Addendum # 2

Bid Opportunity: 25-7630-RFT - Laurentian Public School HVAC and Building Controls Upgrade

E101

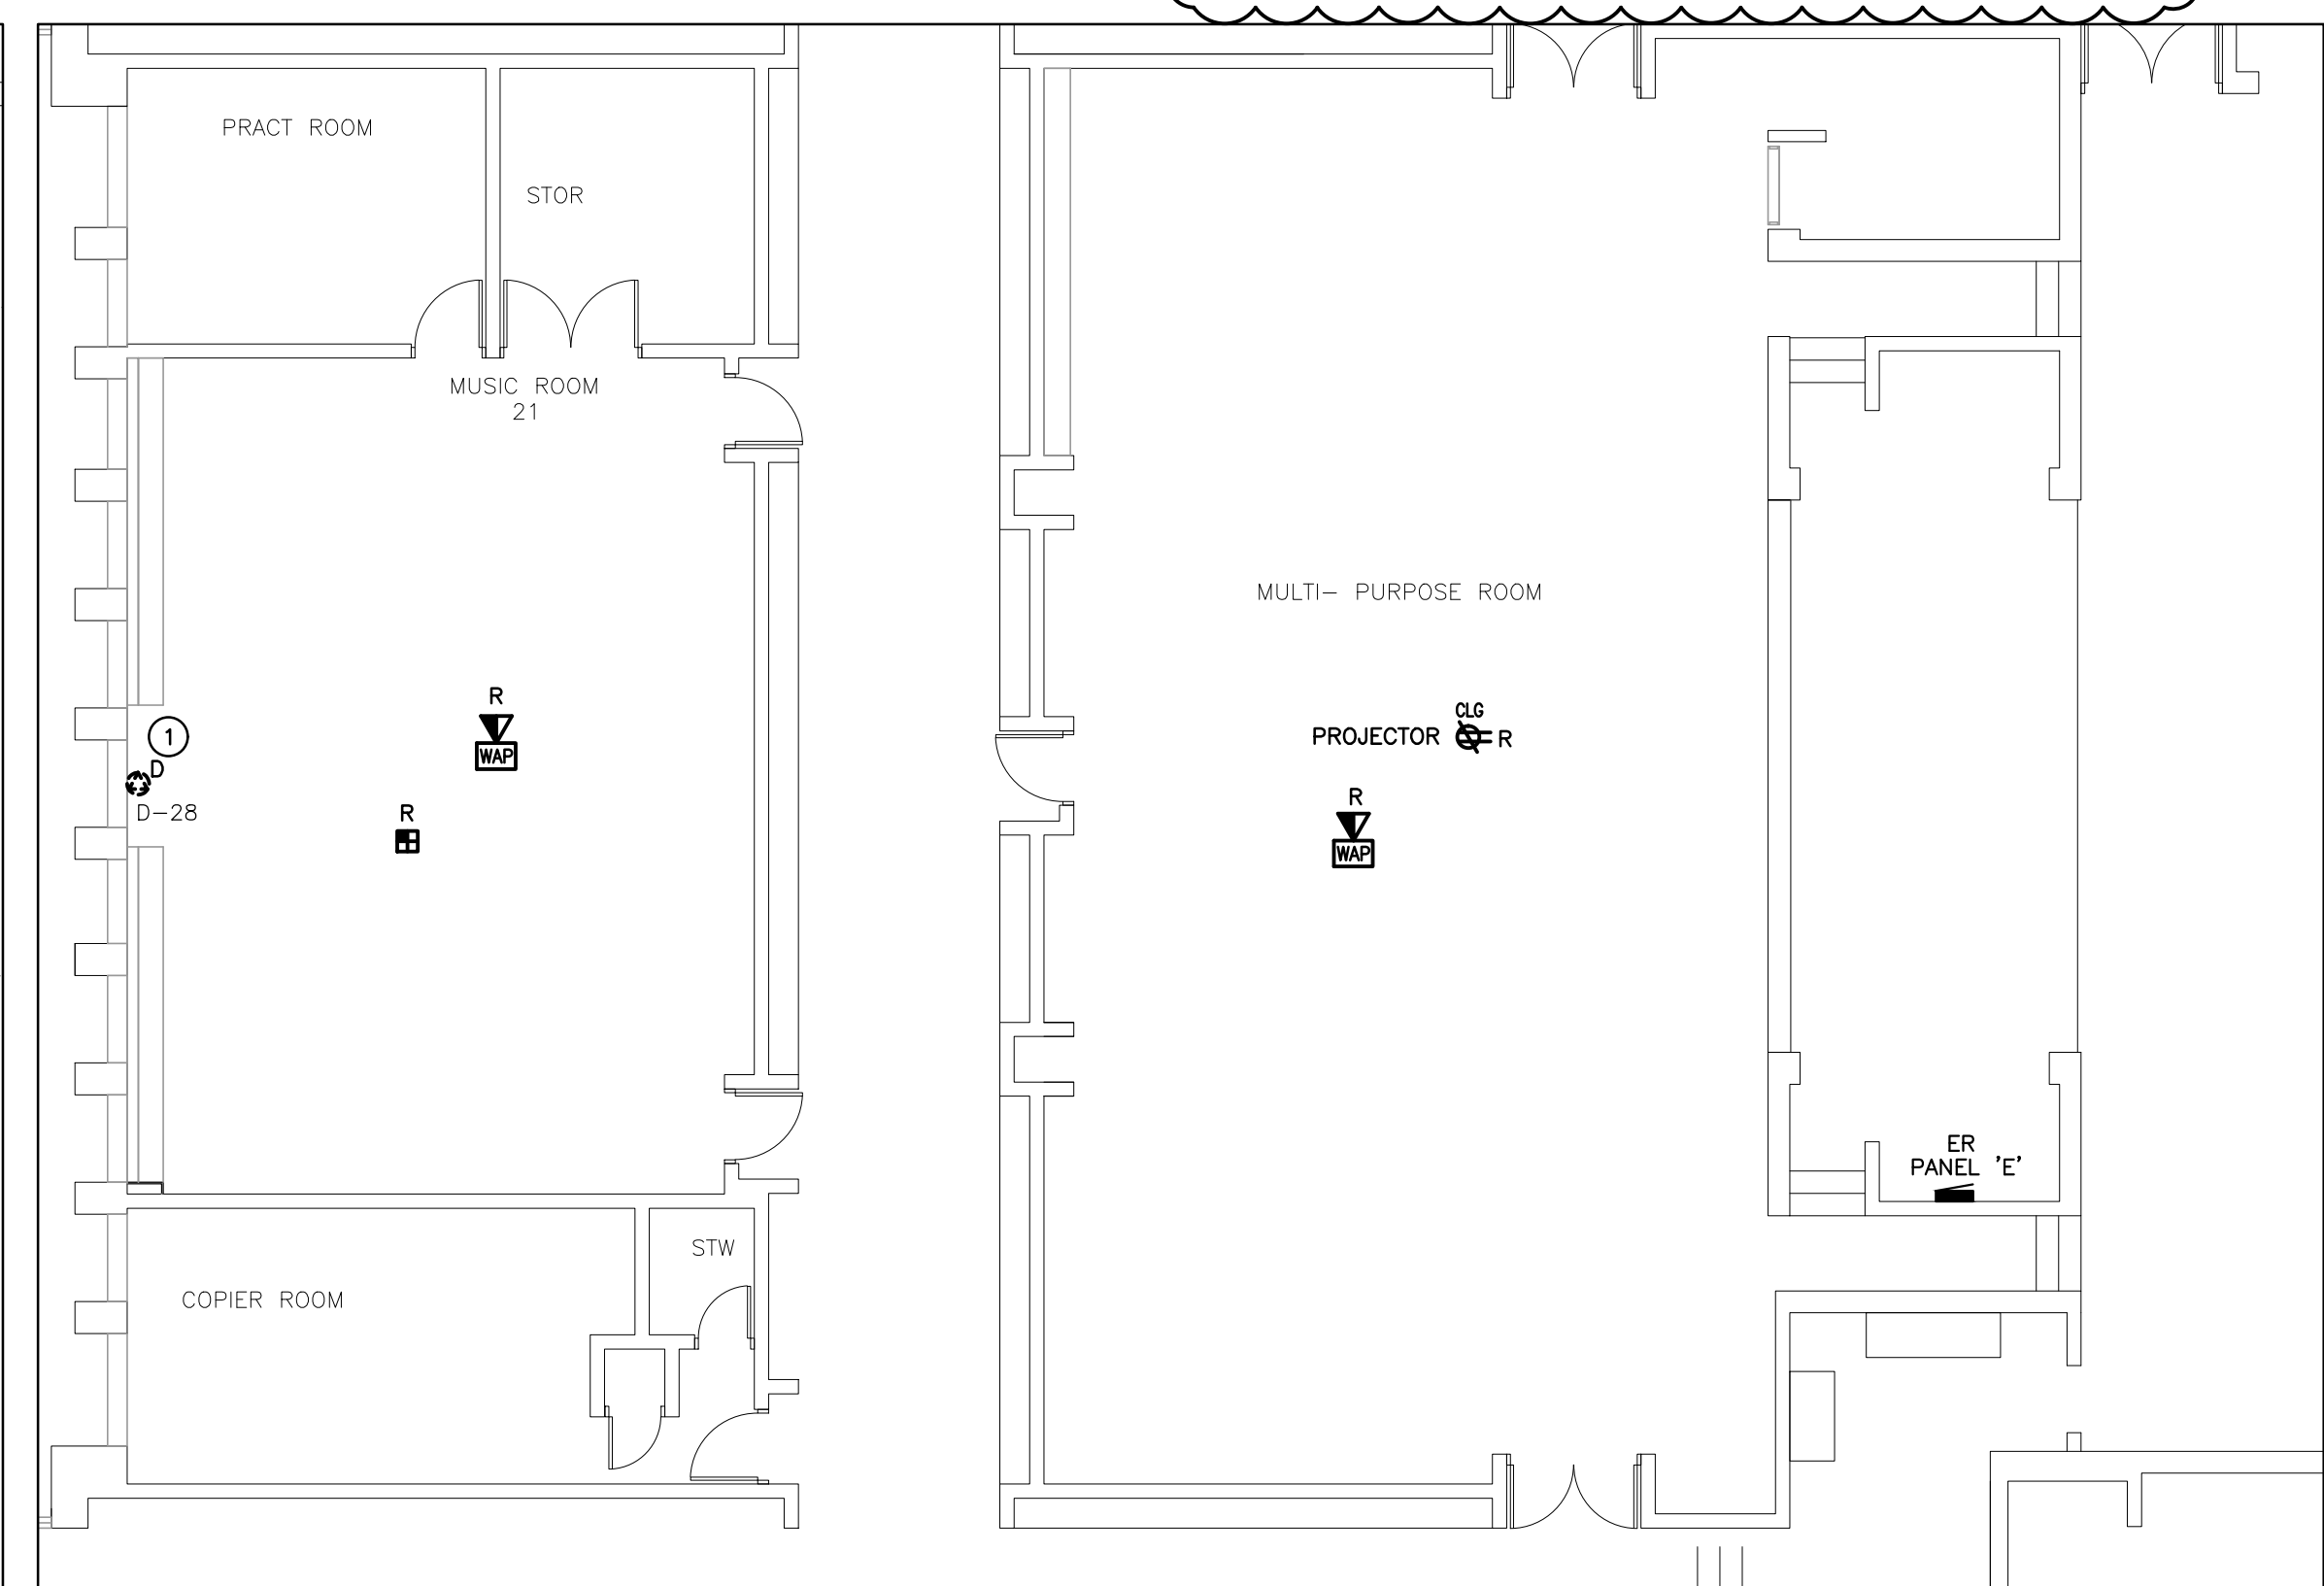
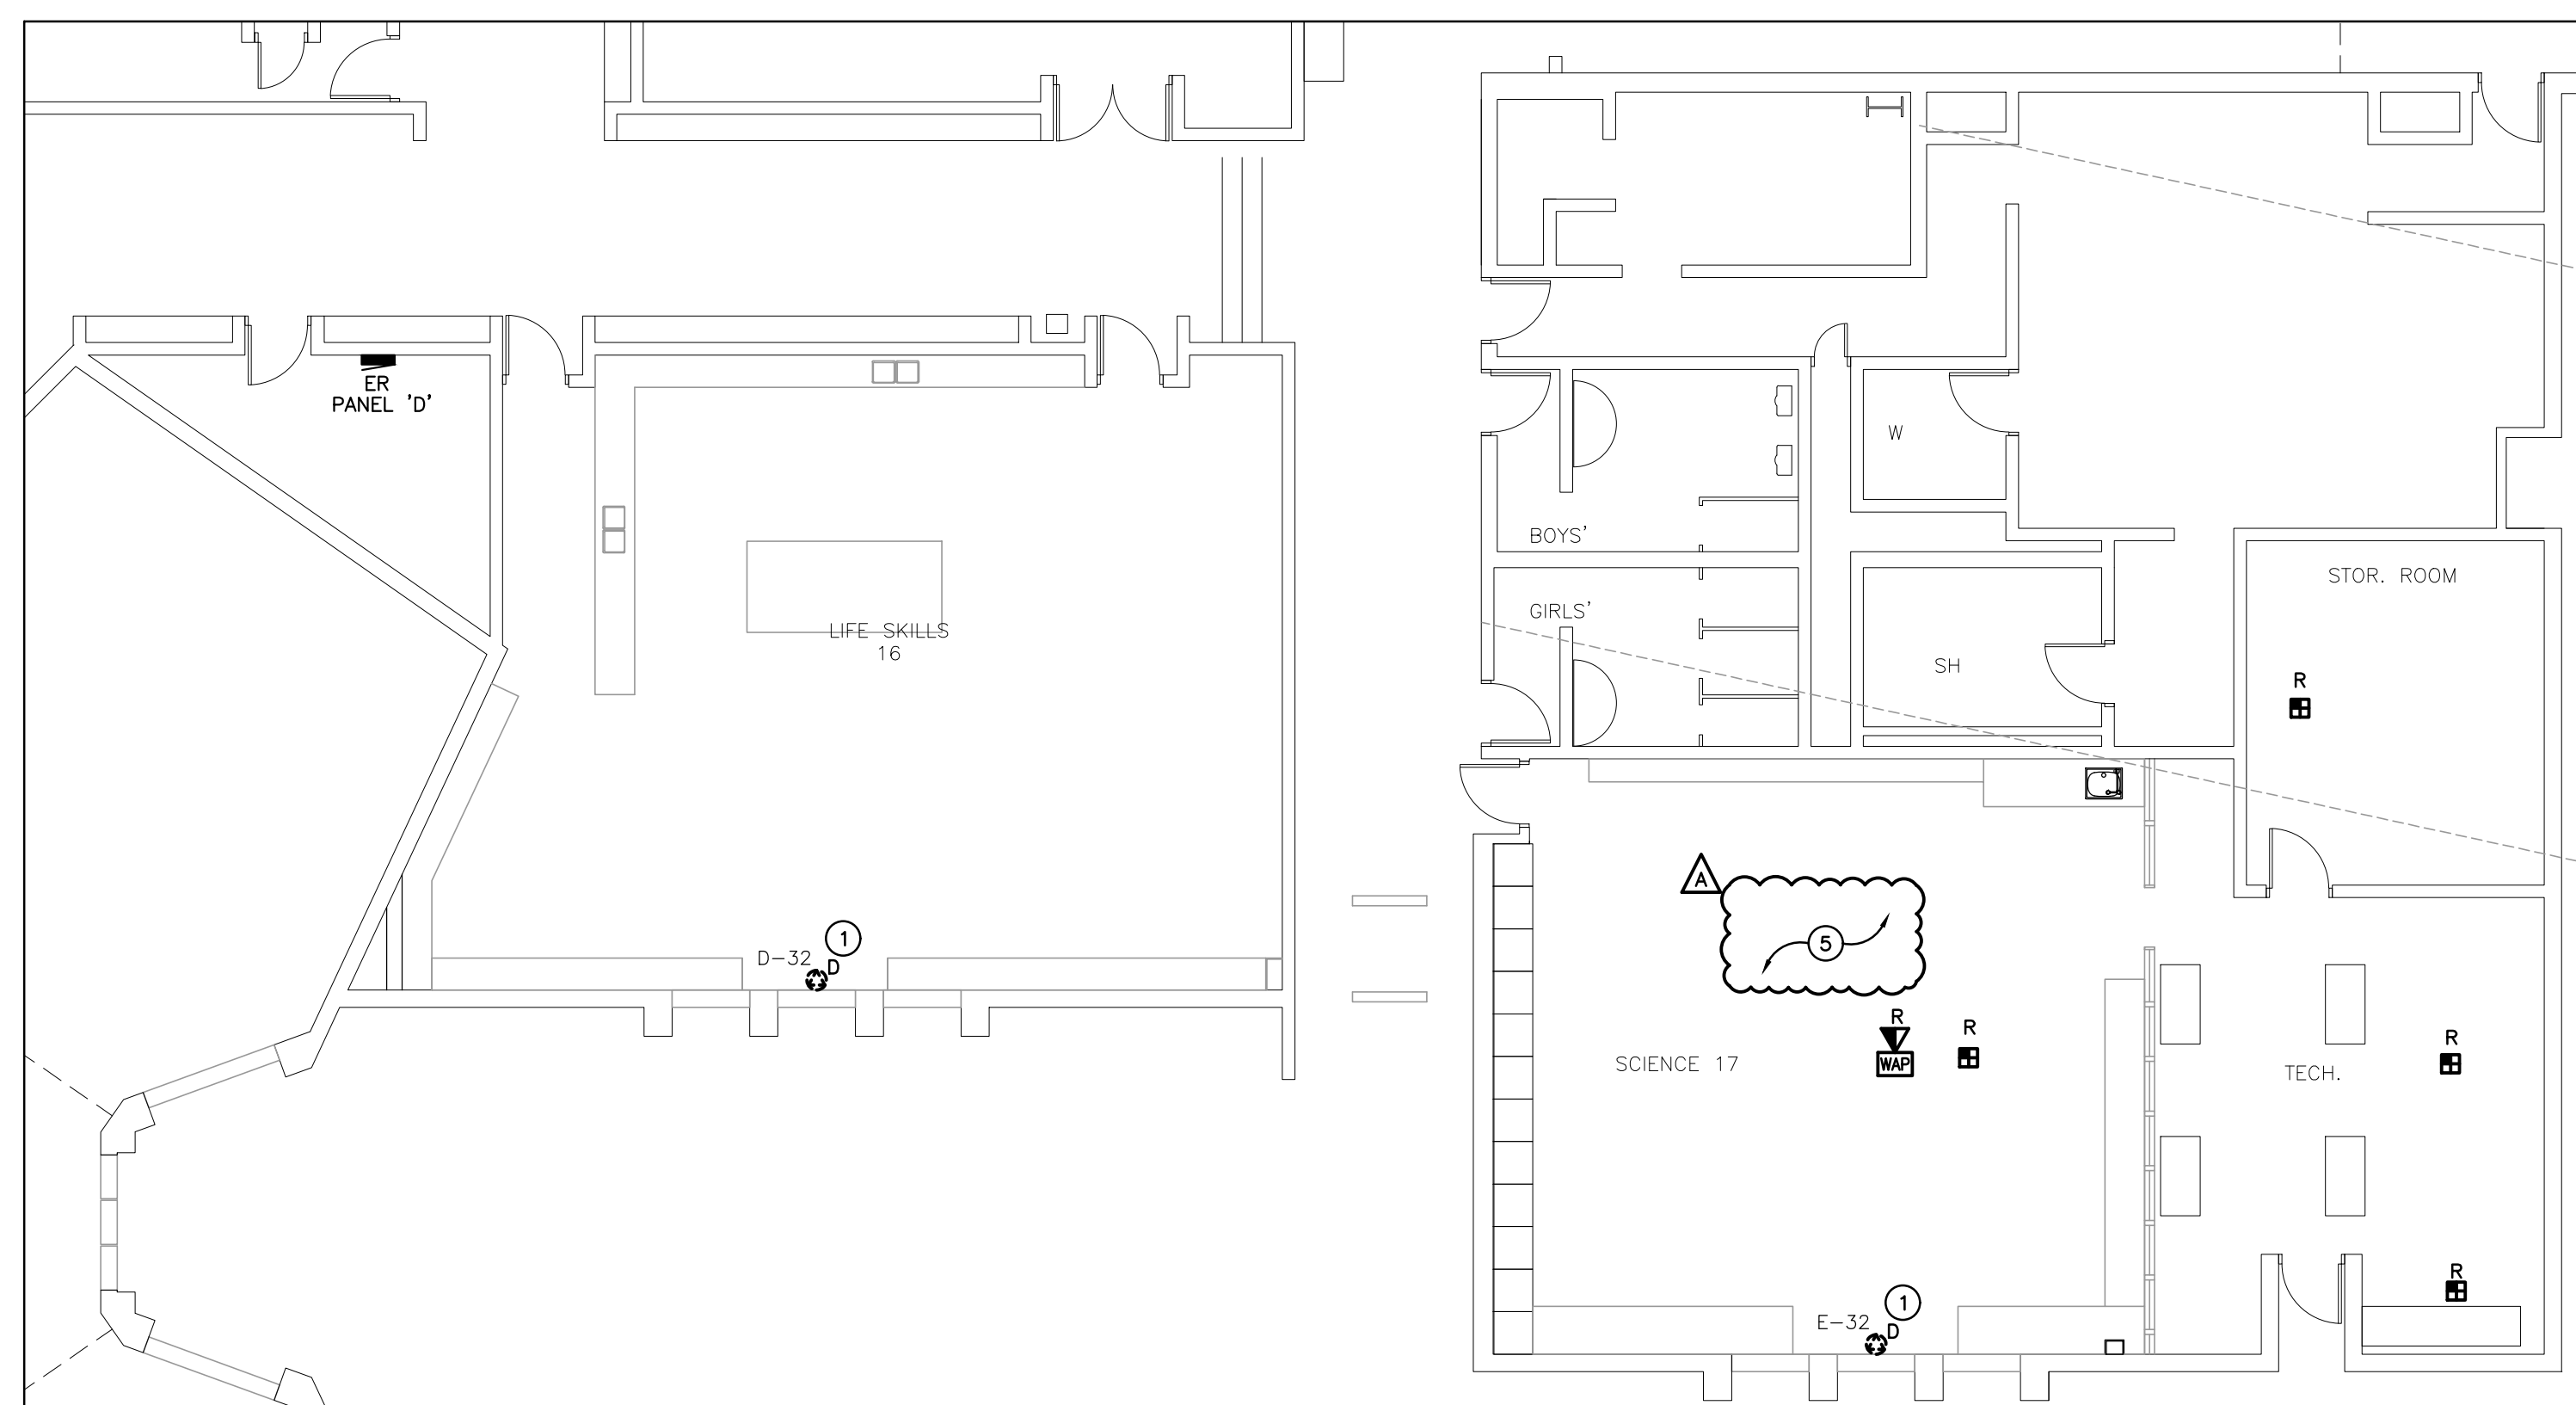
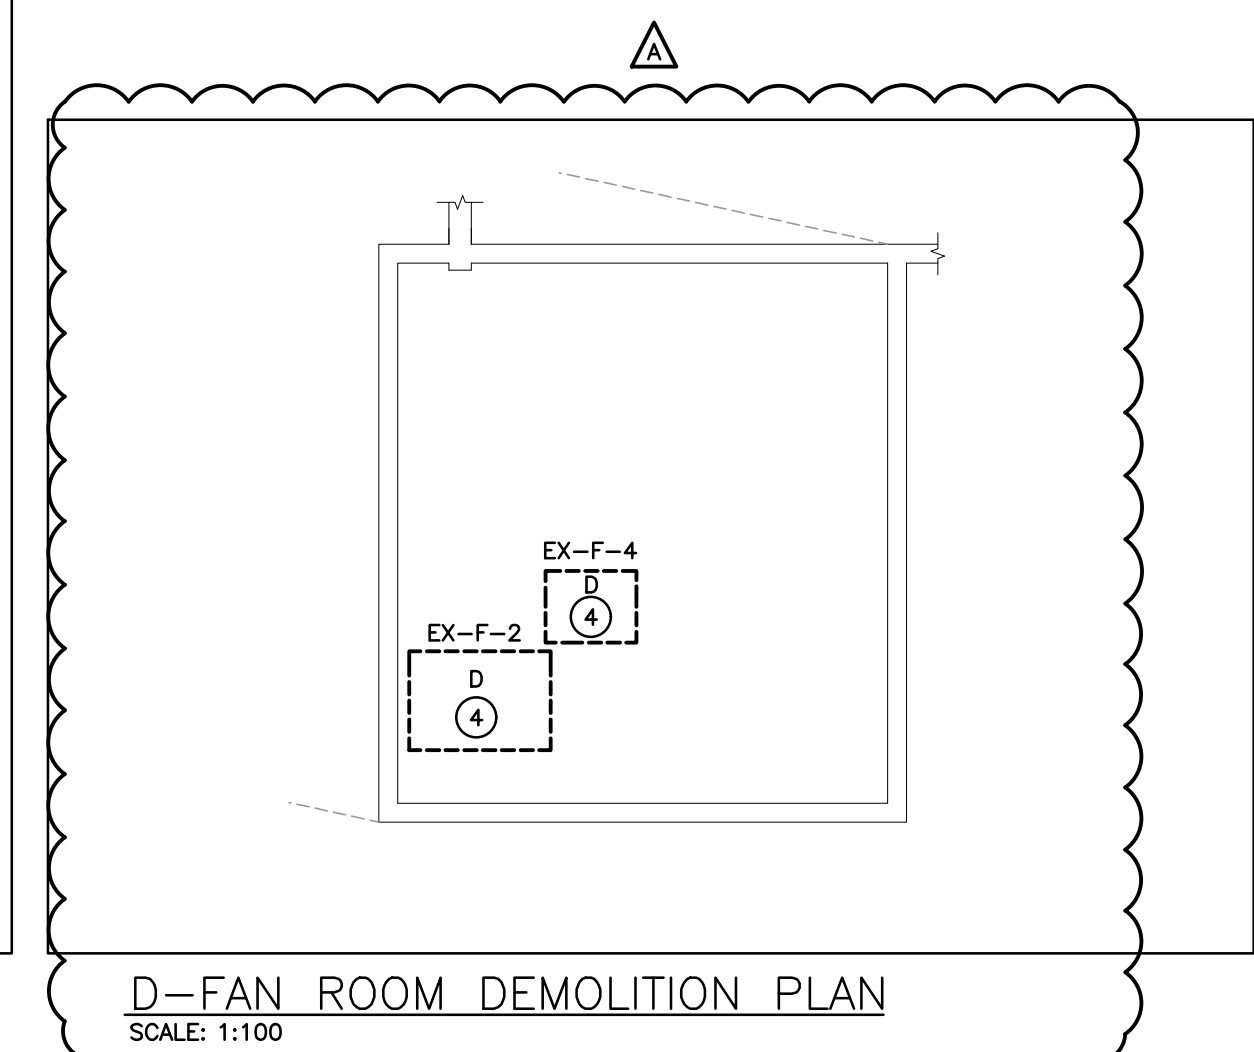
- 2.0 Reference Attached Reissued Drawing E101
 - .1 Add 'Fan Room' to scope of work on key plan as shown.
